200 Forest Way, Belrose NSW 2085 – DA2019/0581

1. I refer to a request from Corona Projects for a traffic engineering assessment of the proposed cafe and construction of car parking spaces at the above address, in reference to Council's Request for Withdrawal for the above Development Application. My assessment is outlined below.
2. The total site area is approximately 12,800 m². The garden nursery occupies only the eastern half of the site and has a Gross Floor Area (GFA) of approximately 5,800 m². The remaining areas include open bulk storage with loading/unloading and truck manoeuvring areas, car parking areas and undeveloped land. Please refer to **Figure 1**.

Dwg No 19083/04 Rev. A 20/12/2019
Client:
Robert Marci

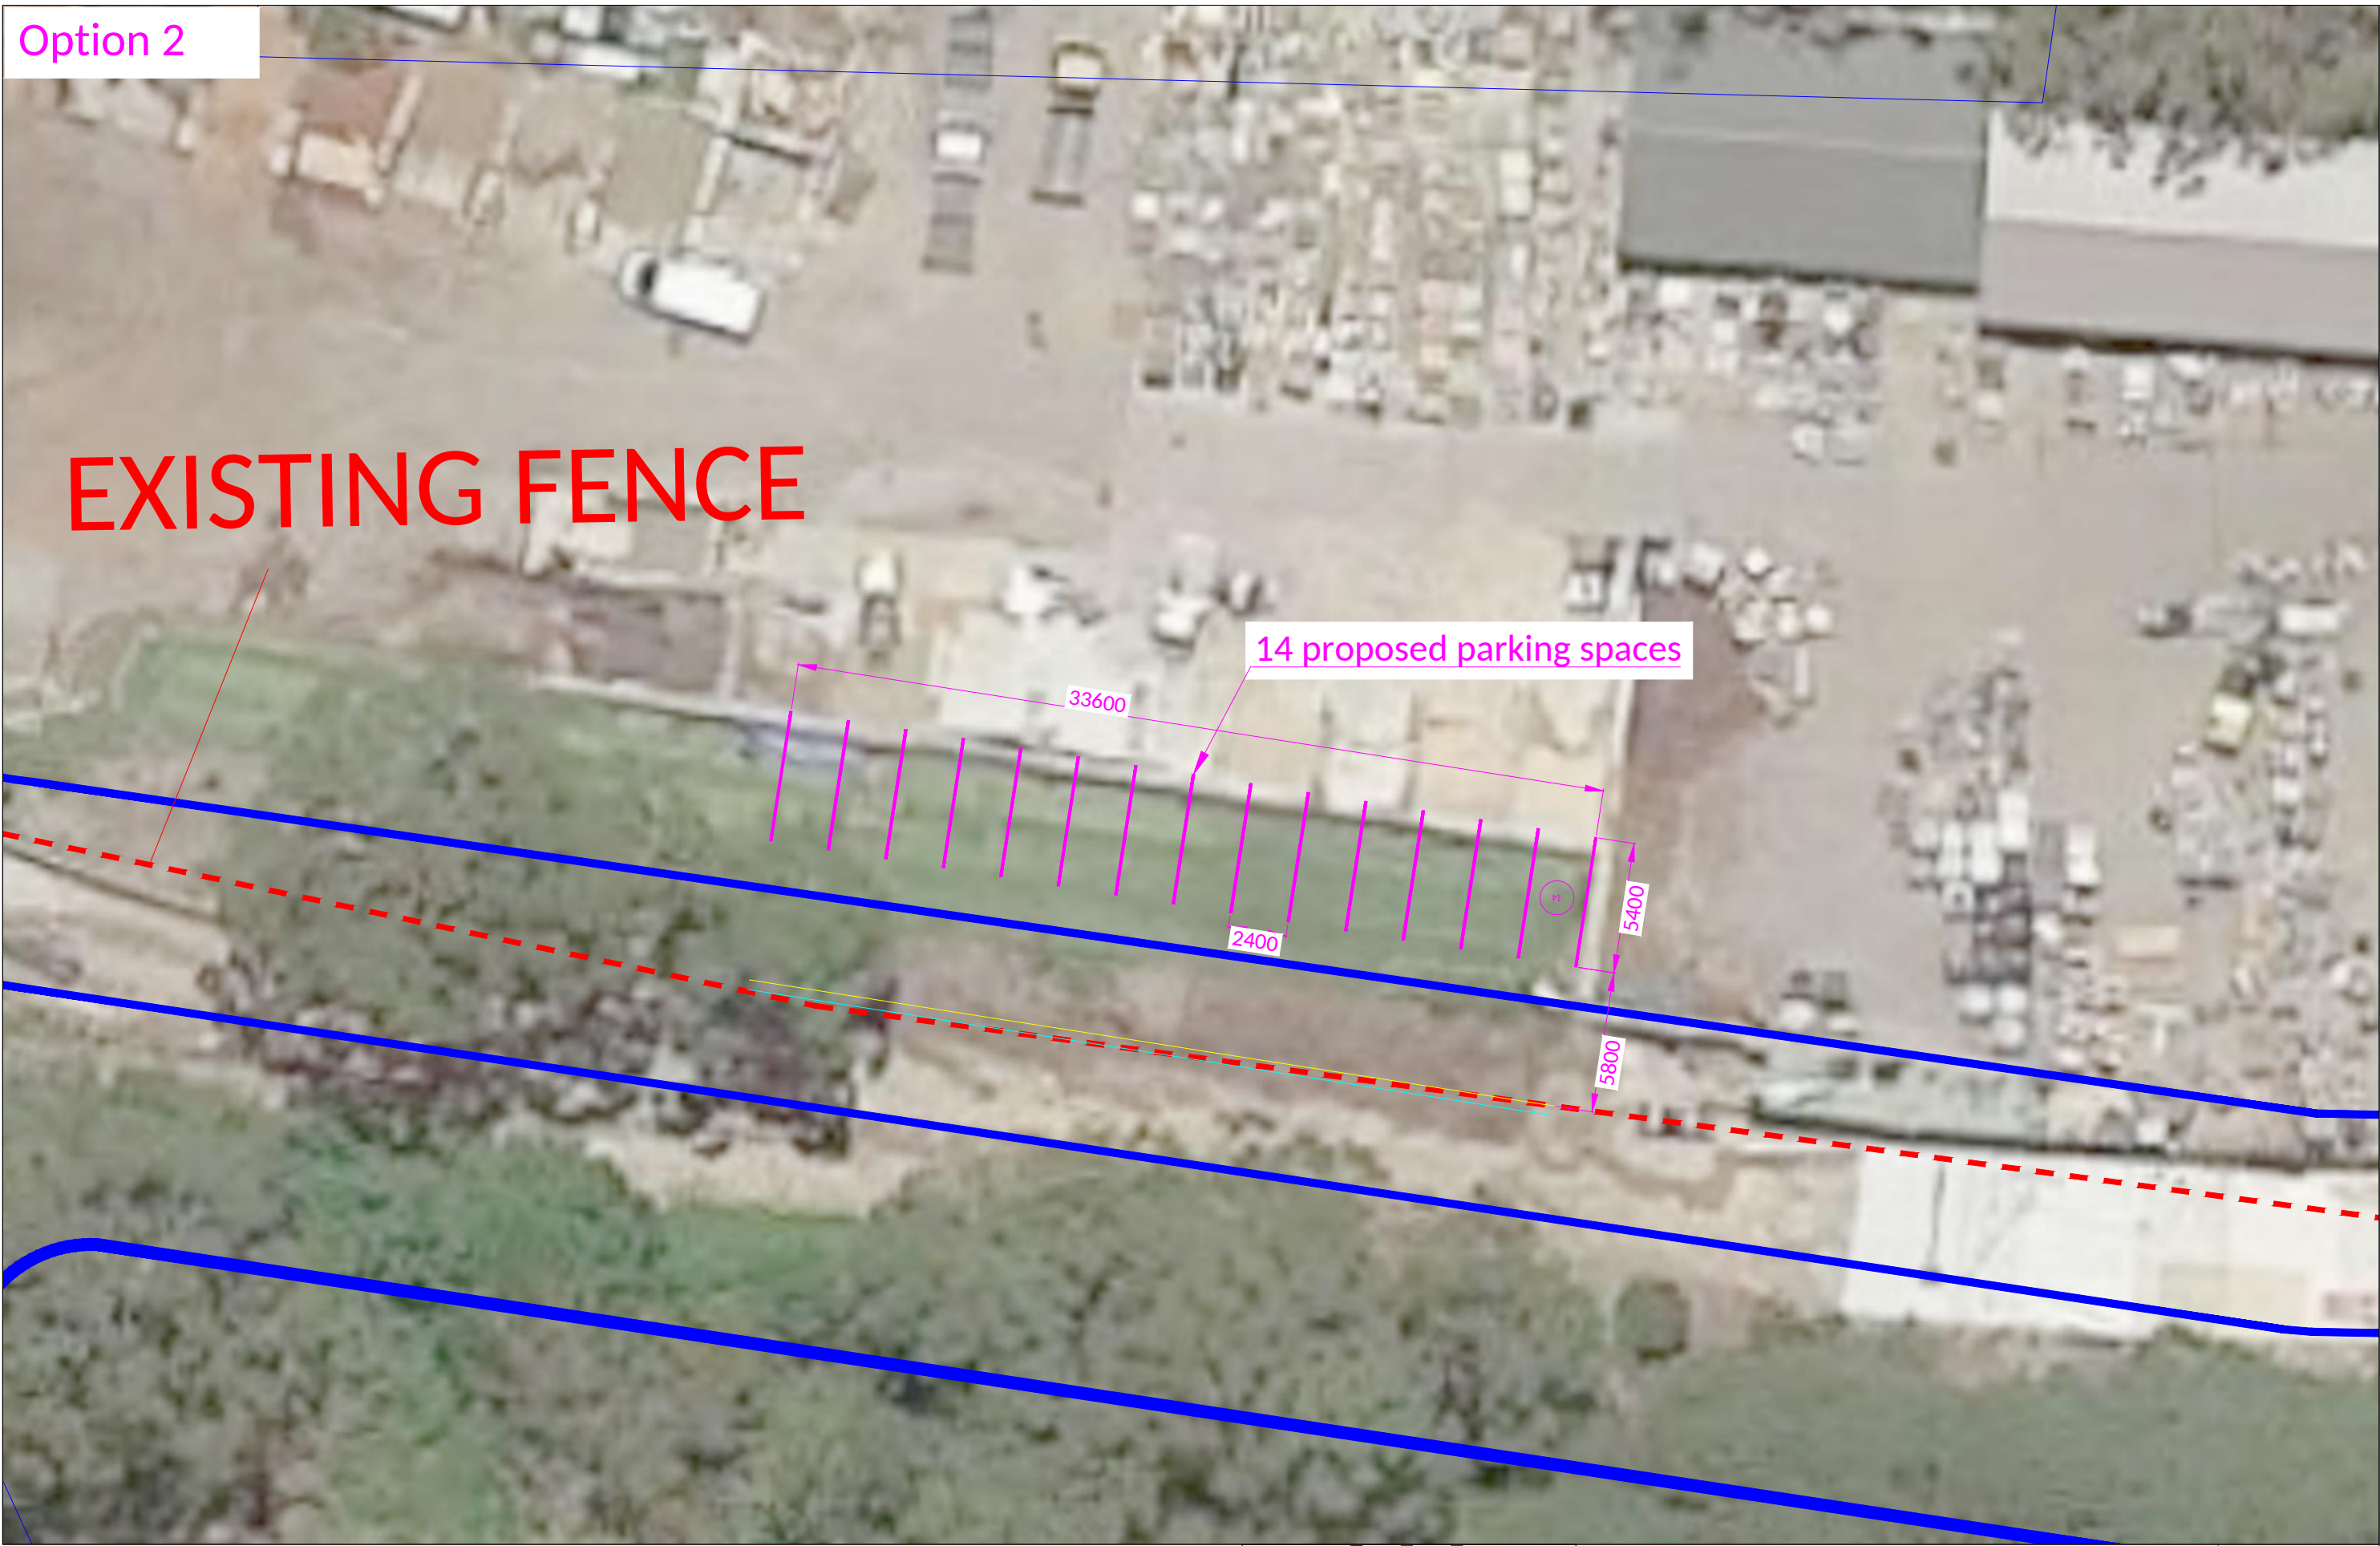
1. Traffic report needs to be submitted certifying the design of the car parking area and turning paths are in accordance with AS 2890. A clear demonstration of satisfactory manoeuvring on-site and forward entry and exist to and from the public road for all spaces.

- Additional staff only parking at the rear of the site – 14 spaces (refer to TEF drawings 19083/04 and 19083/05)
 - a) Total: $30 + 17 + 14 = 61$ spaces

- The car park design is compliant with AS/NZS 2890.1:2004. Vehicle swept paths are produced as per the requirements of AS/NZS 2890.1:2004 and AS 2890.2-2002.
